**SUSQUEHANNA STEAM ELECTRIC STATION
PROPOSED LICENSE AMENDMENT NO. 285 FOR
UNIT 1 OPERATING LICENSE NO. NPF-14 AND
PROPOSED LICENSE AMENDMENT NO. 253 FOR
UNIT 2 OPERATING LICENSE NO. NPF-22 EXTENDED
POWER UPRATE APPLICATION RE: REACTOR SYSTEMS
TECHNICAL REVIEW REQUEST FOR ADDITIONAL
INFORMATION RESPONSES
PLA-6250**

**Docket Nos. 50-387
and 50-388**

Attachment 2 to PLA-6250
Non-Proprietary Version of the Request for
Additional Information Responses

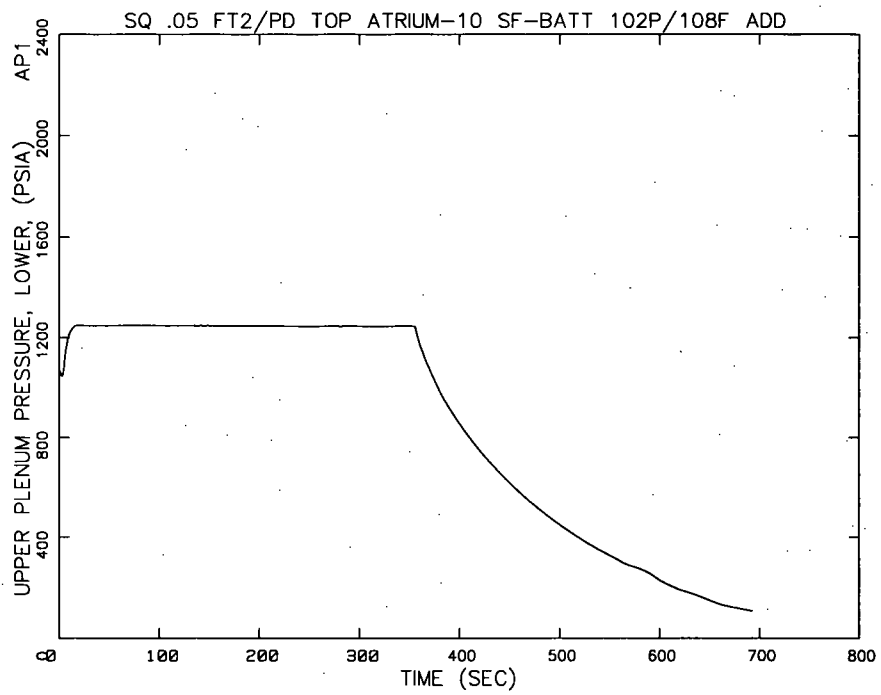
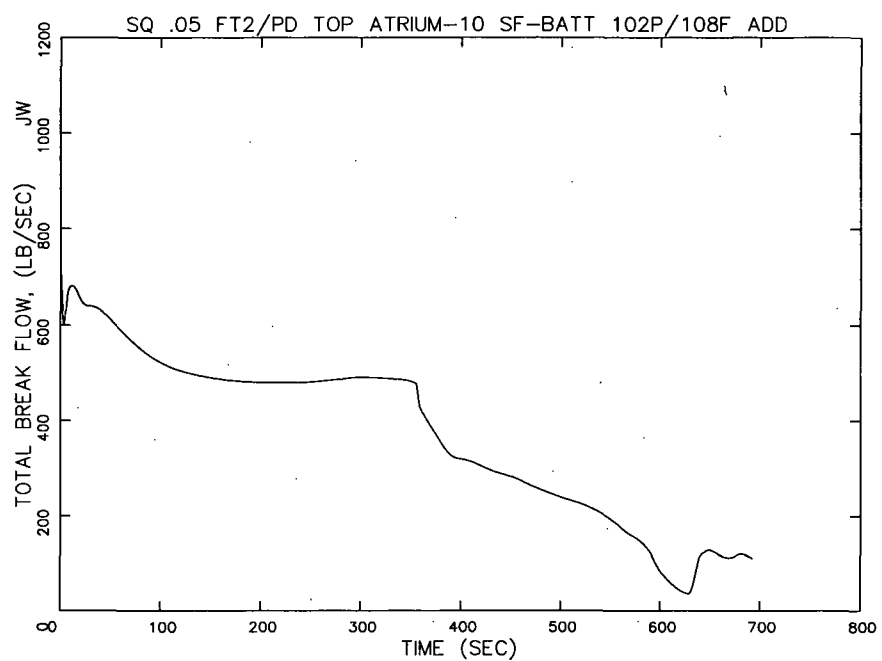
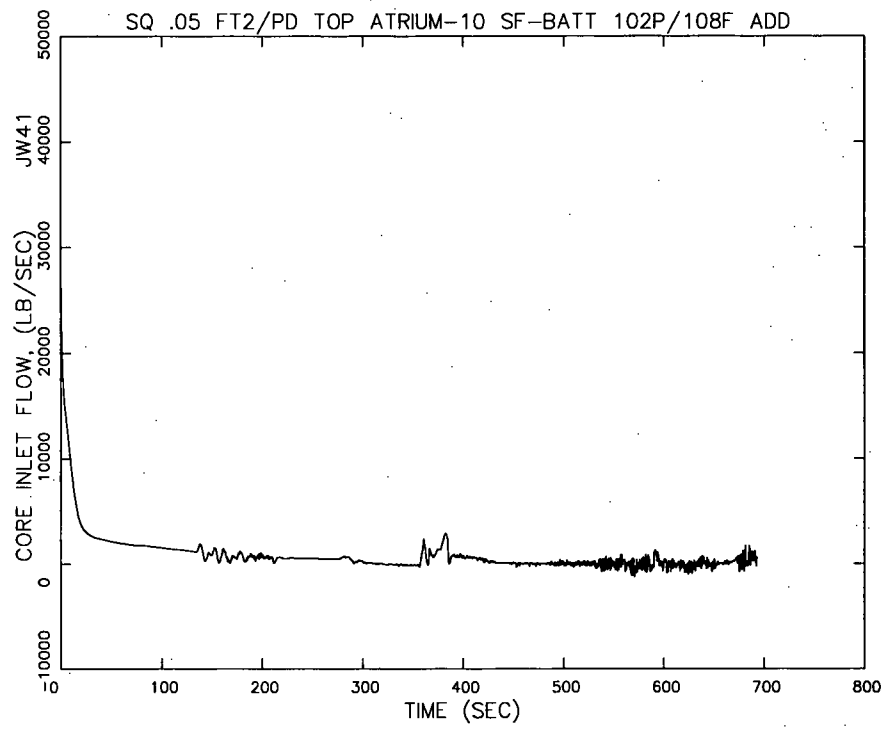
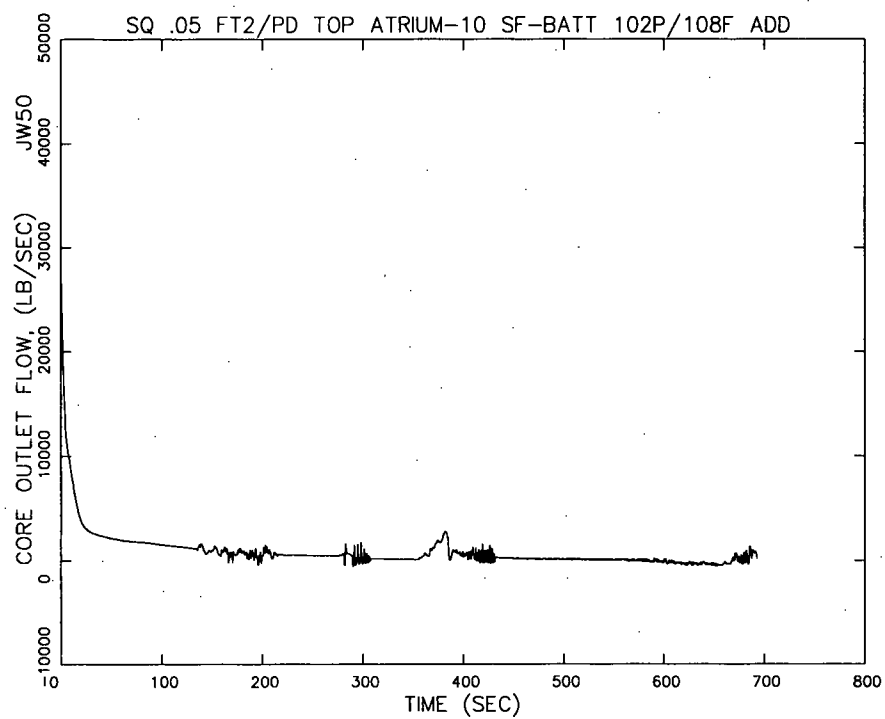
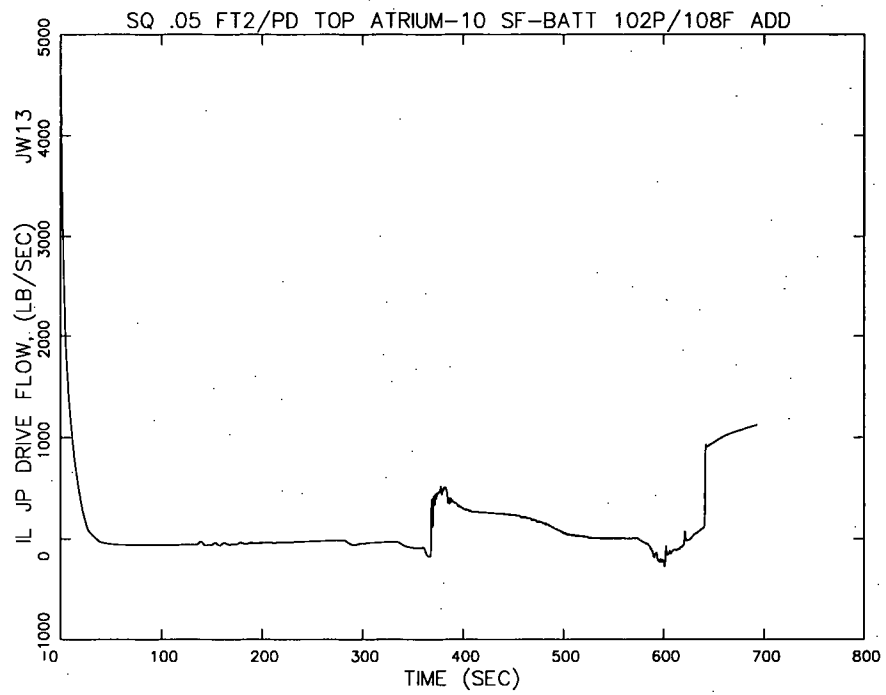
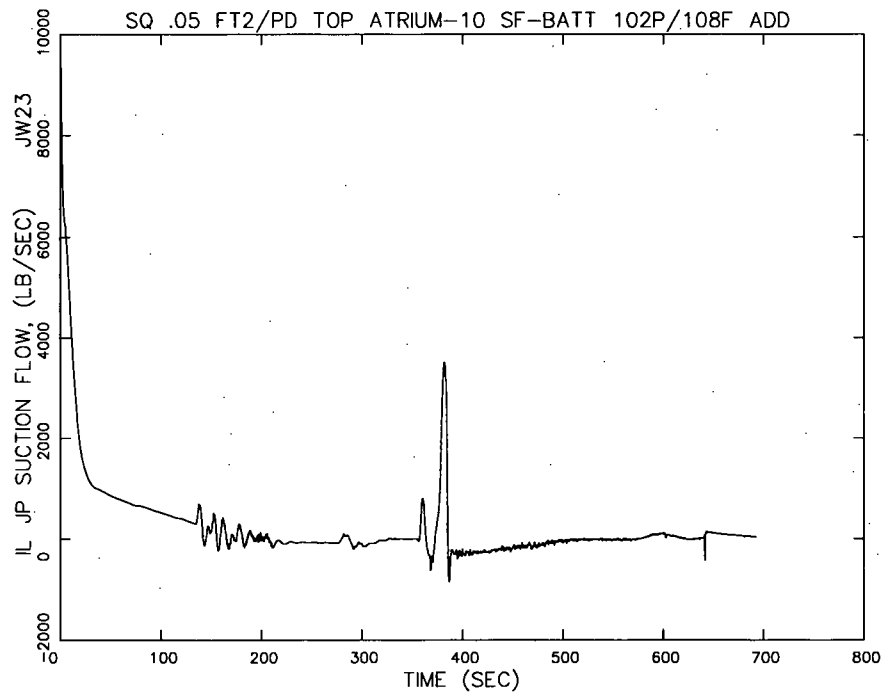
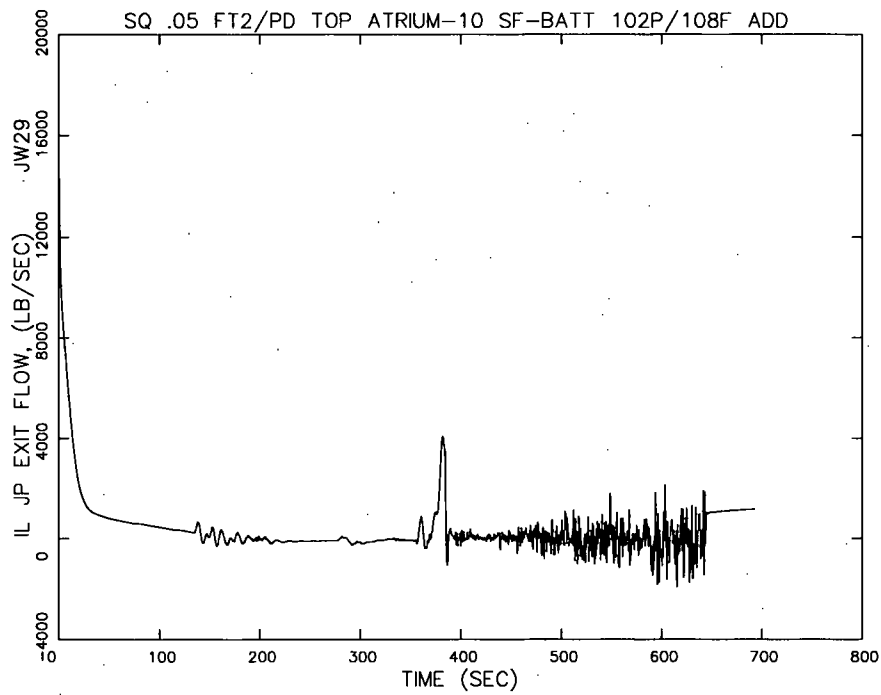
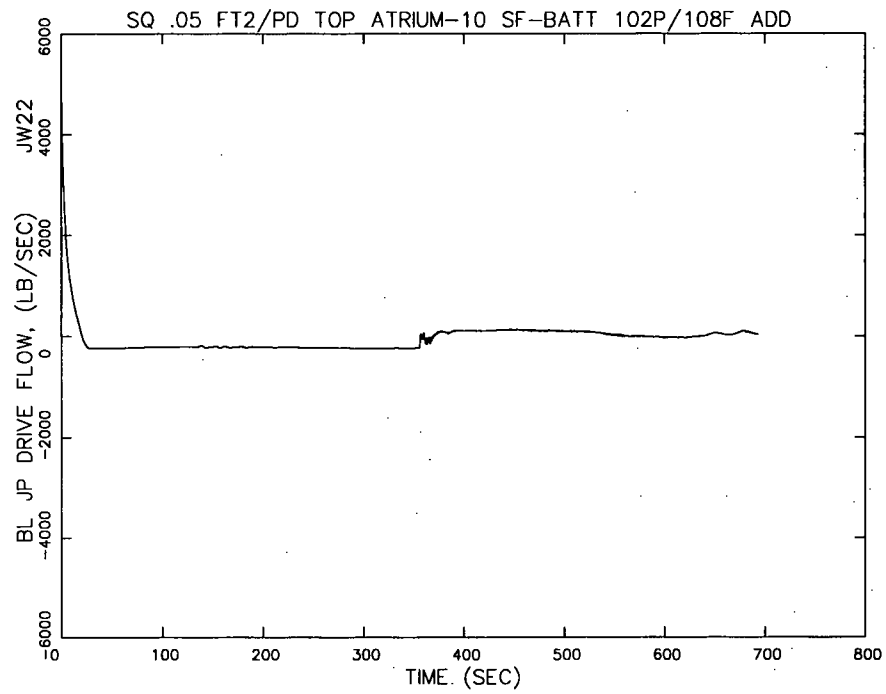
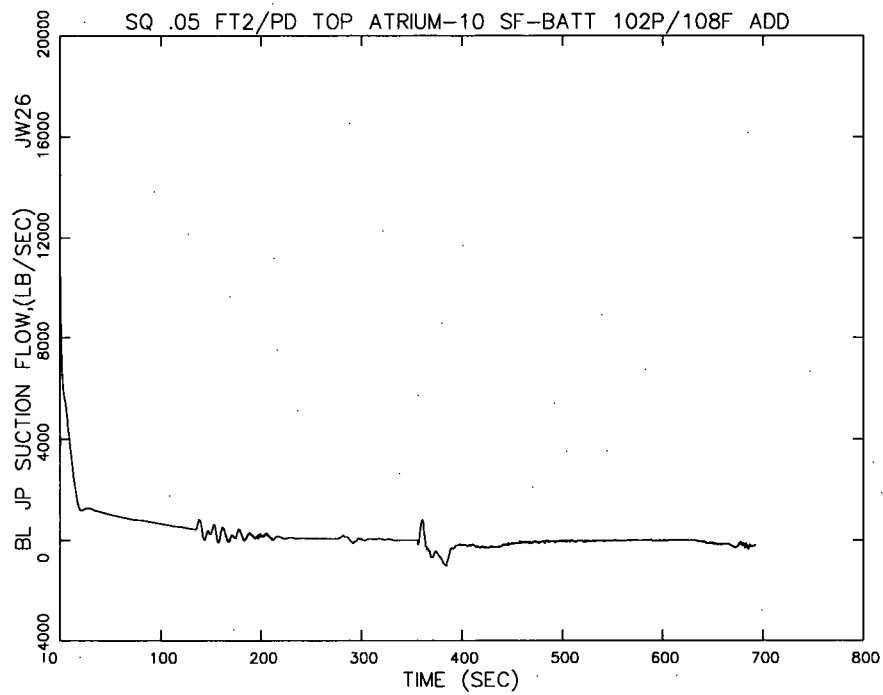
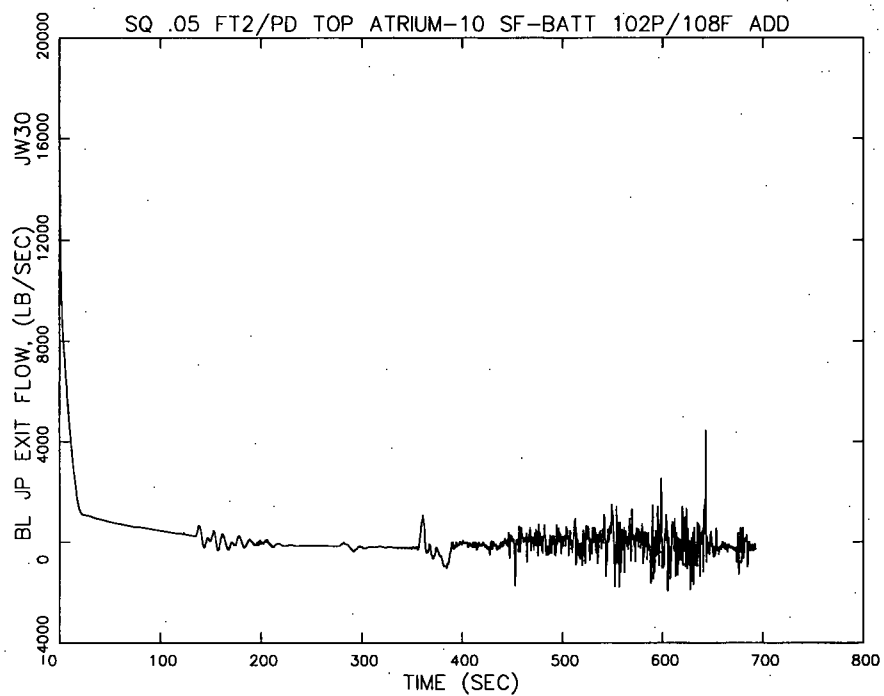
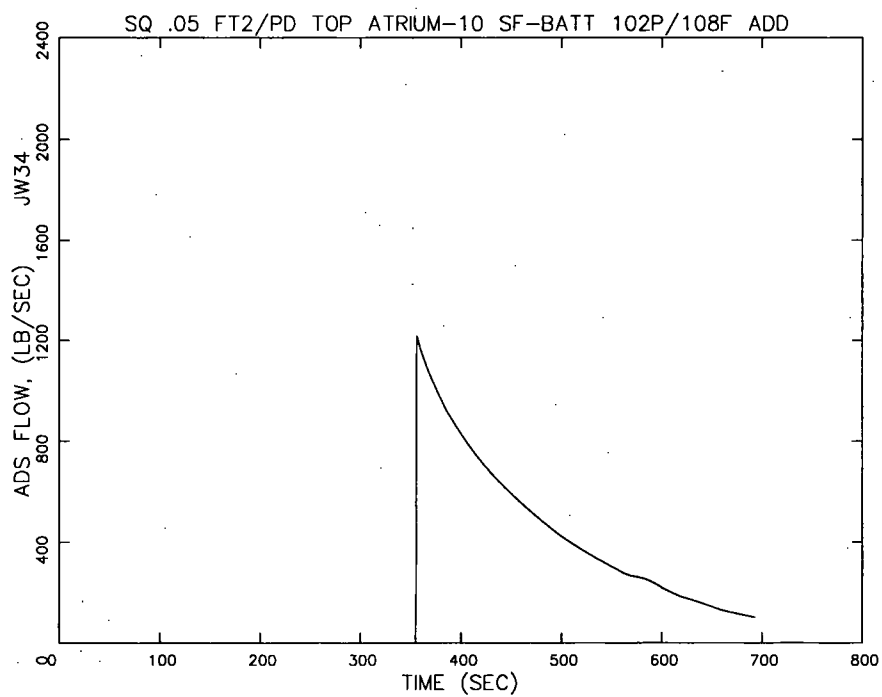
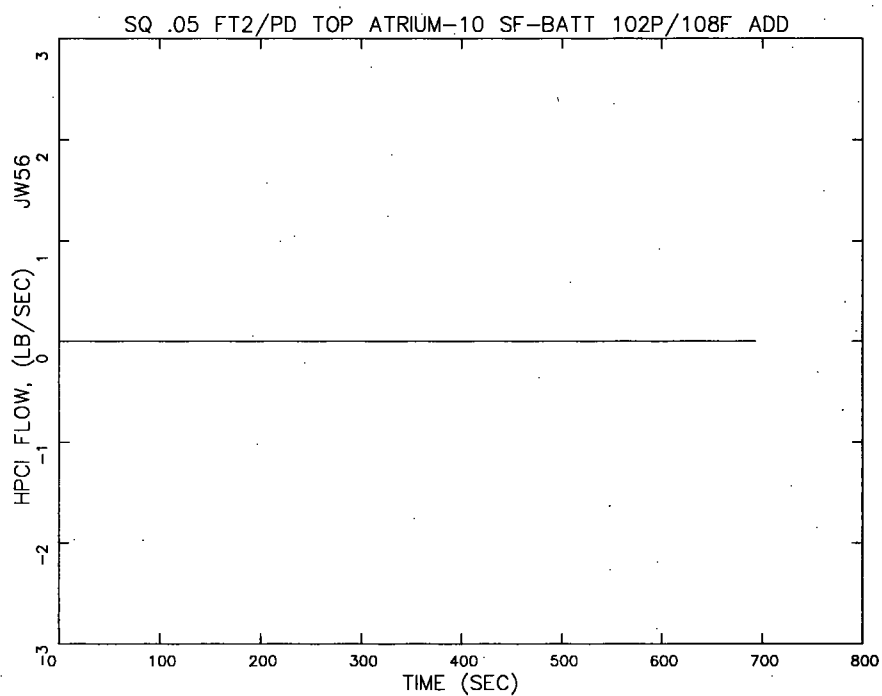
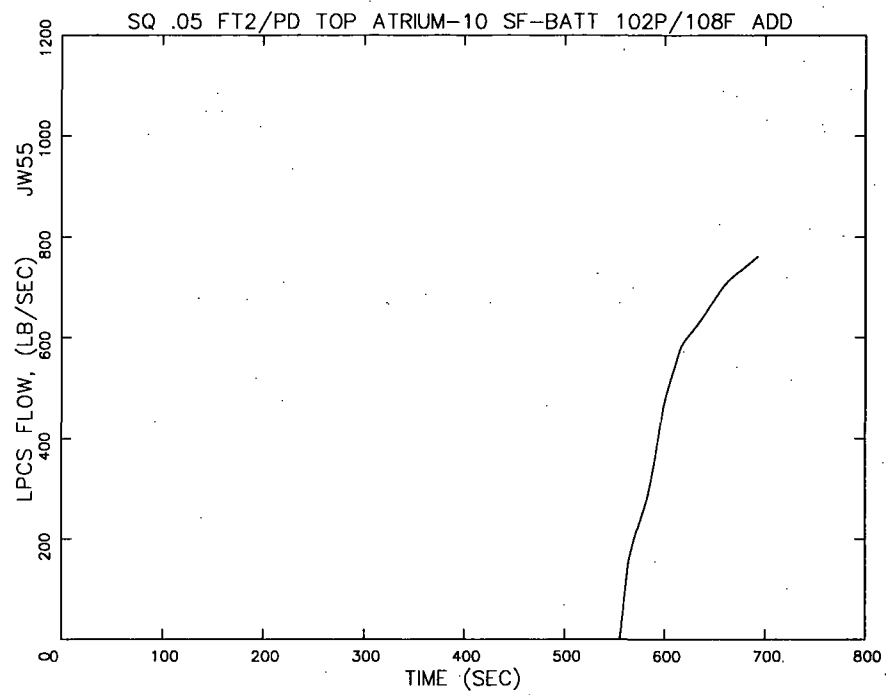
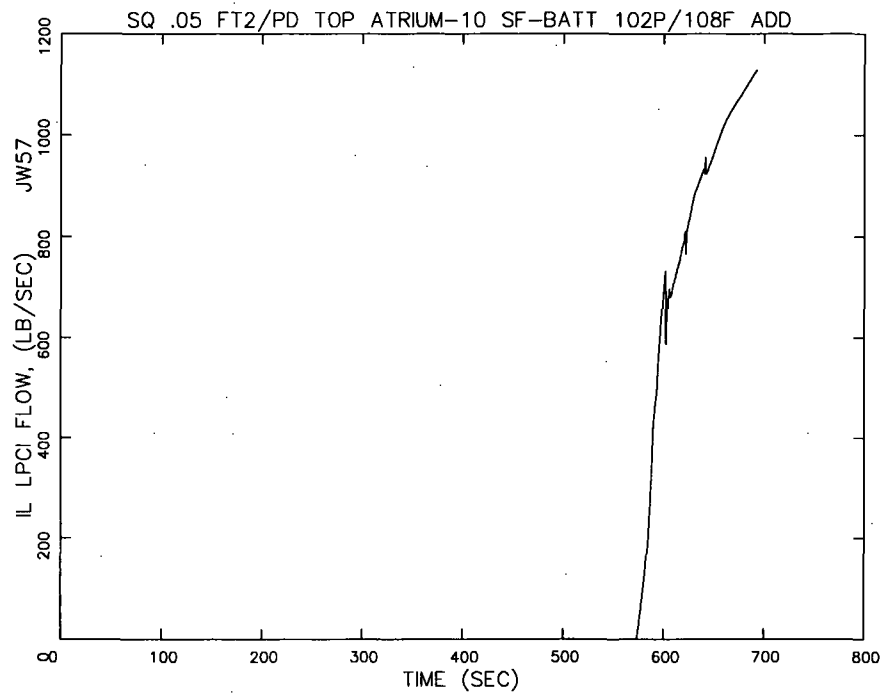
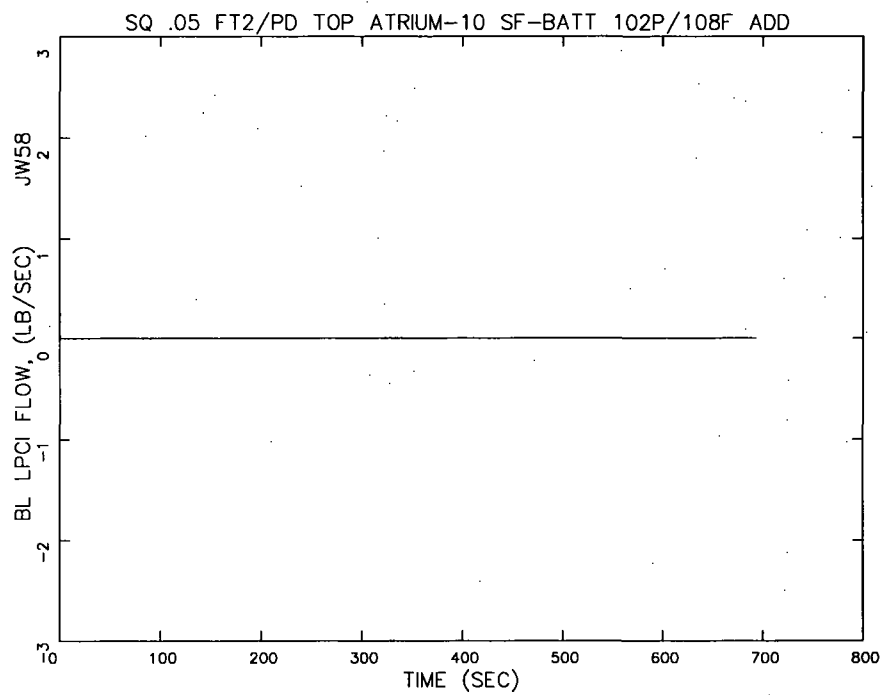
The staff performed a small break LOCA with break size less than 0.1 ft² at recirculation pump discharge side. The break characteristics include initial core flow of 108 Mlbm/hr, 102% power, top-peaked axial power profile and SF-BATT. The staff found the PCT in this break size range (less than 0.1 ft²) is much more limiting compared to break size at 0.7 ft² case. Please provide small break LOCA analysis result at break size of 0.05 ft² with same break characteristics. Please include major parameter plots as shown in the LOCA report (EMF-3242P, Revision 0) for TLO large break LOCA.

AREVA performed the requested small break calculation for 0.05 ft², initial core flow of 108 Mlbm/hr, 102% power, top-peaked axial power profile and SF-BATT. The PCT for this small break was calculated to be 1296°F, which is lower than the limiting large break PCT and lower than the limiting small break PCT calculated with AREVA methods. The sequence of events for the requested small break calculation is provided in Table A.1 followed by a set of major parameter plots similar to the LOCA report.
